TECHNICAL MEMORANDUM

Reference No. 20446521-007-TM-Rev0-6000

LMI RESPONSE TO CIRNAC'S COMMENTS ON THE DOME DESIGN ISSUED FOR CONSTRUCTION DRAWINGS FOR WATER LICENCE NO. 2AM-LUP2032 – LUPIN MINE PROJECT

TITLE
PROPOSED WASTE ROCK DOME SECTIONS AND DETAILS

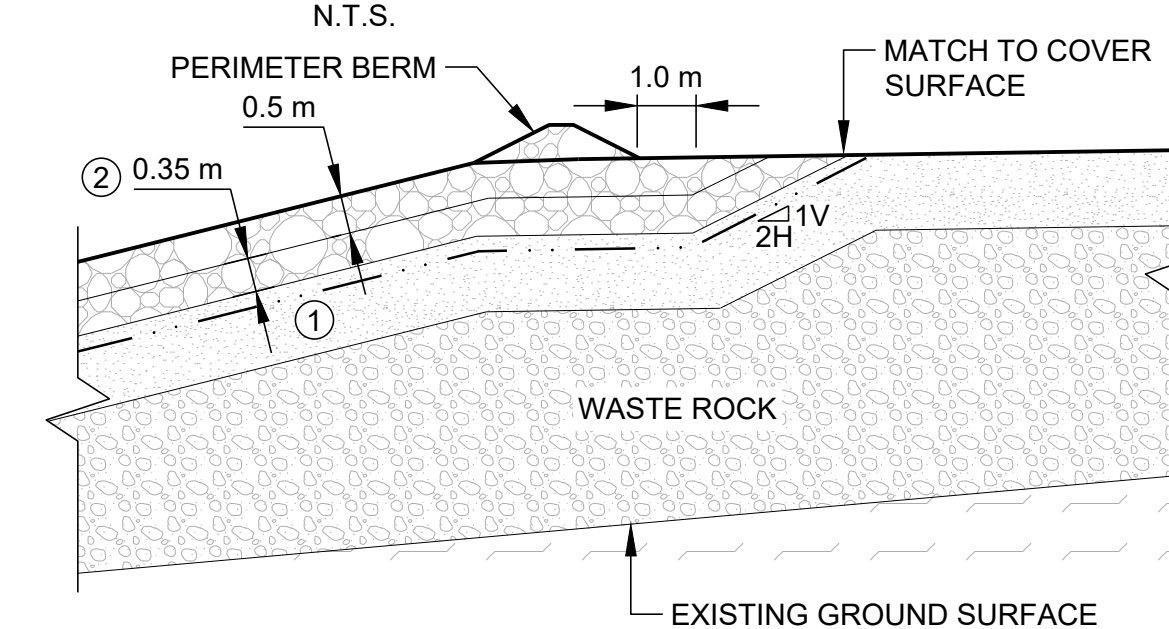
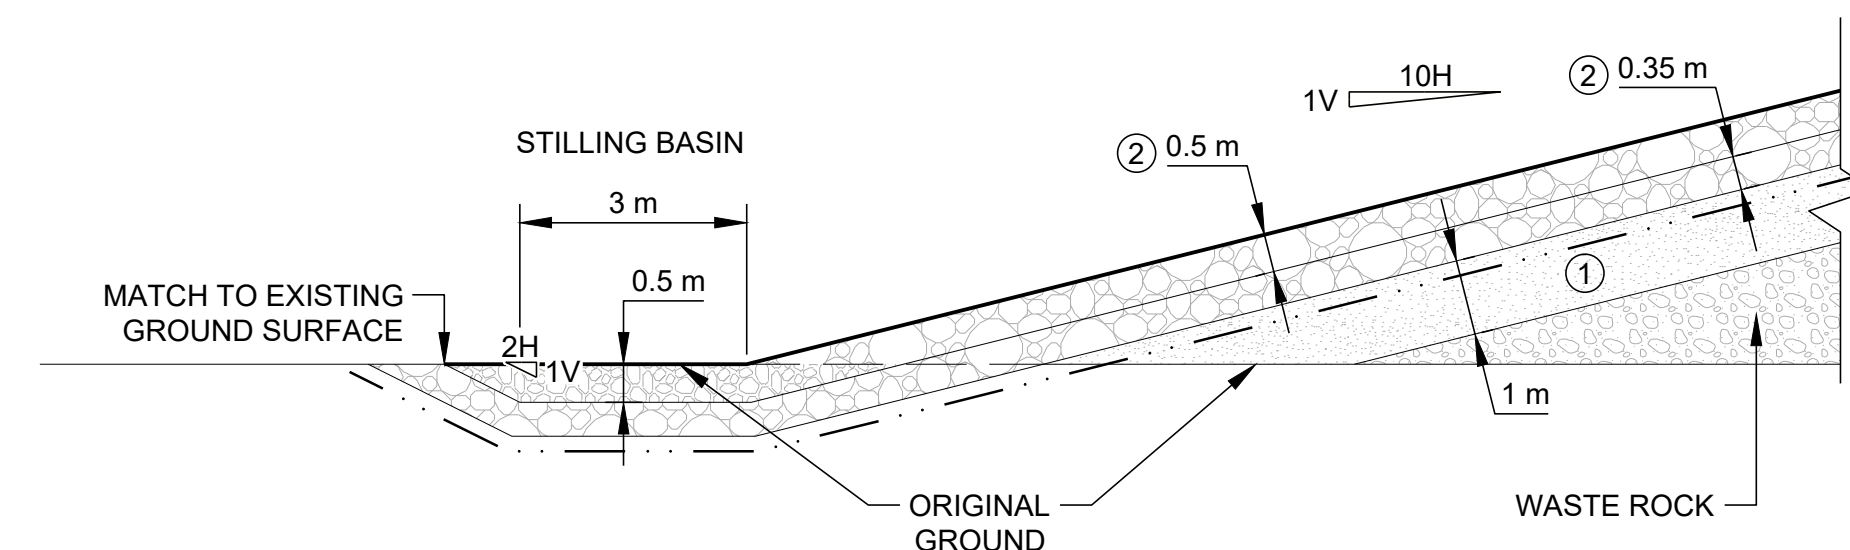
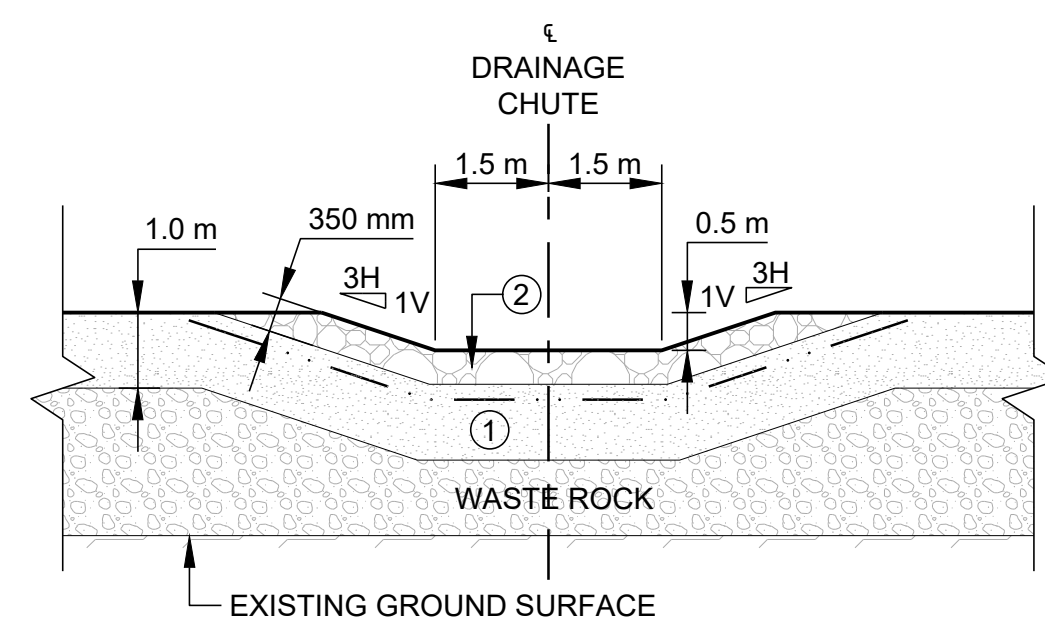
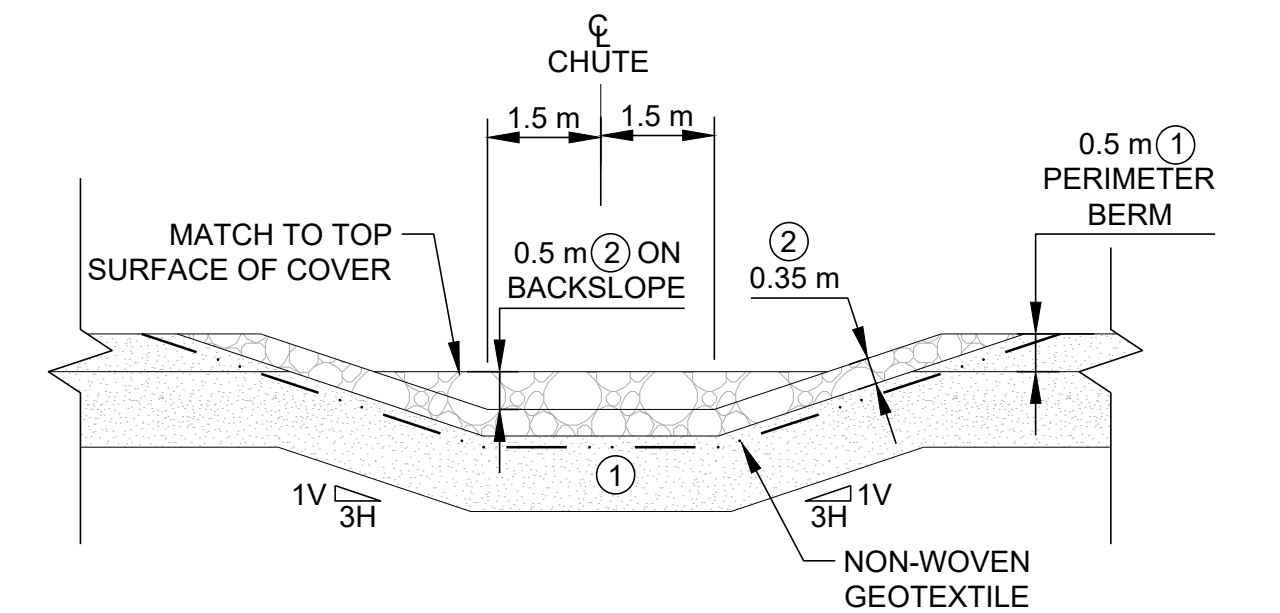
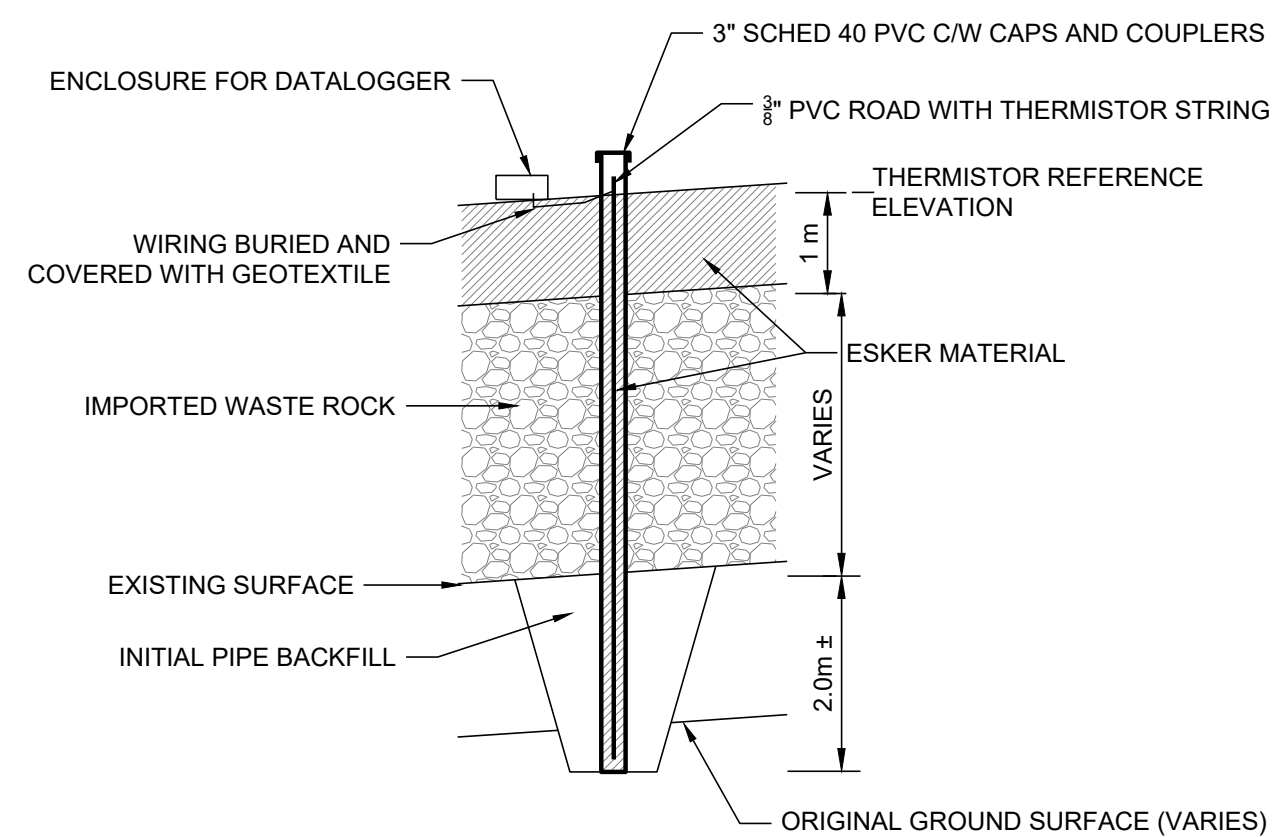
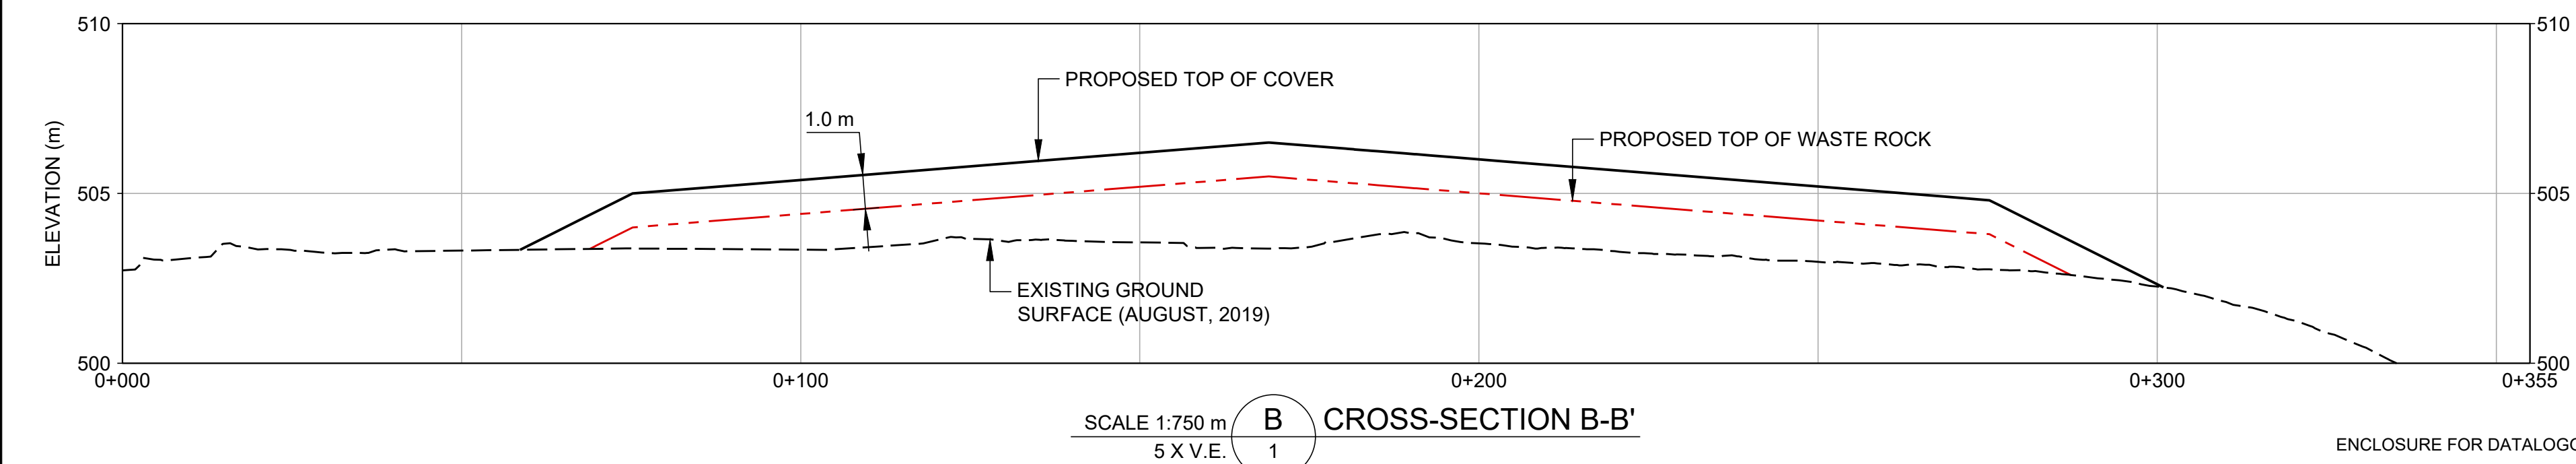
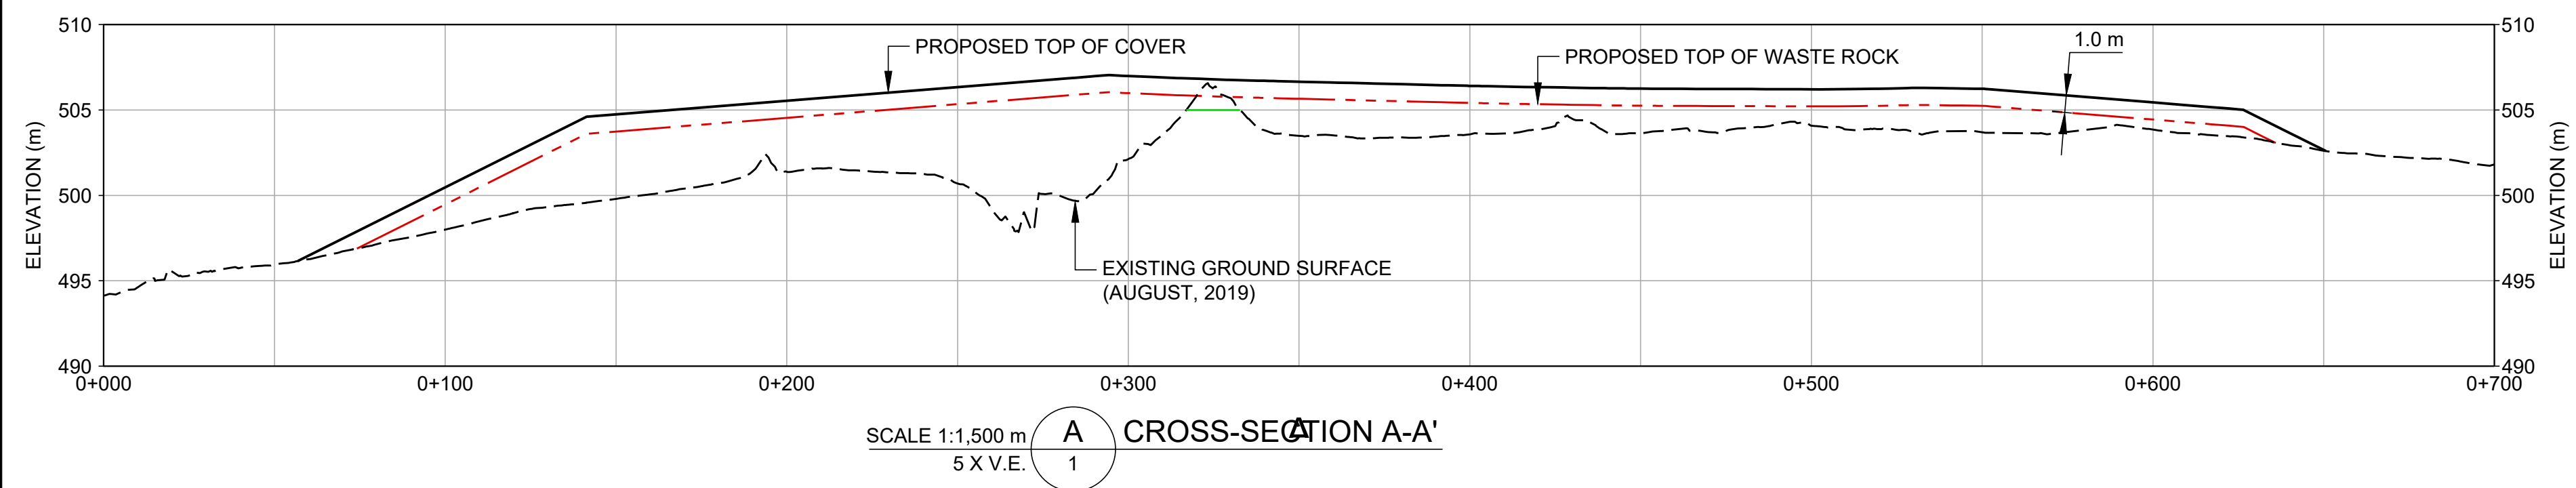
#	Issue	Concern	Recommendation	LMI Response
a	Berm Construction	<p>In the "Typical Detail of Perimeter Berm", the berm is shown as comprised of "esker" material. In the "Drainage Chute Typical Profile", the perimeter berm is shown as "10kg Erosion Protection" material.</p> <p>From the drawing it is not clear what materials will be used to construct the berm.</p> <p>It will be helpful to show if there is a transition from esker to "10kg Erosion Protection" material at the top of the chutes.</p>	CIRNAC recommends that LMI clarify berm construction materials.	The perimeter berm is to be constructed of Zone 1 esker material. The intention is that a 350 mm thick layer of Zone 2 erosion protection on geotextile be placed at the bevelled end of the perimeter berm at the entrance to each of the chutes. Refer to Dwg 19136158-0002-CM-0001_Rev 2 (attached) for definition of material zonation.
b	Drainage Chute Typical Profile – Stilling Basins	<p>The typical section shows the stilling basin below the original ground level. Given that LMI has indicated that drainage chutes will discharge on native surfaces that are either rock or glacial till, it is unclear if this detail will apply if the native surface is rock.</p> <p>Does LMI intend to construct the basins into rock, and if not, what will be done in this situation?</p>	CIRNAC recommends that LMI clarify the design of the stilling basins if native rock is found at the toe of the chute discharge location.	It would not be necessary to construct/excavate a stilling basin into a bedrock outcrop. Note 10 has been added to Dwg 19136158-0002-CM-0001_Rev 2 (attached) to clarify this. It reads, "The stilling basin shall be deleted if the chute ends on a bedrock outcrop." As a field fit, berms of Zone 2 erosion protection would be extended to laterally contain the hydraulic jump over the bedrock surface.

c	Drainage Chute Typical Profile, Section Entrance to Drainage Chute – Non- woven Geotextile	<p>These typical sections show the presence of non- woven geotextile in the esker cover beneath the erosion protection layer. LMI did not provide any dimensions with respect to depth of esker material over the non-woven geotextile fabric, nor are any details provided on anchoring the non-woven geotextile fabric. Normally we would expect that non-woven geotextile be anchored at the top and the sides down the chutes. It should not daylight at surface as indicated on the drawing details.</p>	CIRNAC recommends that details and/or notes should be provided to ensure that the non-woven geotextile is placed, covered, and anchored as appropriate.	<p>The non-woven geotextile is to be placed on top of the esker material to act as a filter between the esker and the overlying Zone 2 erosion protection. (On the drawing, the geotextile line is shown slightly below the interface for visibility only.)</p> <p>There is no need to anchor the geotextile. The friction between the geotextile and the esker material is adequate to resist any movement for the profile and sideslope angles. Any geotextile that daylights above surface is redundant.</p>

#	Issue	Concern	Recommendation	LMI Response
d	Esker Cover at Toe of Rock Dome Slope	The "Typical Detail of Edge of Waste Rock Dome" shows 1 m esker cover material extending to the "original ground" surface. No armouring or stabilizing elements are included for the toe of the cover, nor are there any notes with respect to subsoil requirements/conditions at the "original ground" prior to placement of the cover materials.	CIRNAC recommends that LMI Provide: <input type="checkbox"/> Notes on any requirements necessary prior to placing materials on original ground along the toe of the dome slopes. <input type="checkbox"/> Technical assessment supporting that the toe of slope does not require some form of toe stabilization to mitigate long term erosion potential along the toe.	It is necessary to prevent any concentrated flow along the toe of the dome cover. To this end, note 11 has been modified on Dwg 19136158-0002-CM-0001_Rev 2 (attached) to read, "Construct ditches or berms as necessary to direct flow from drainage chutes and general runoff away from the dome fill."
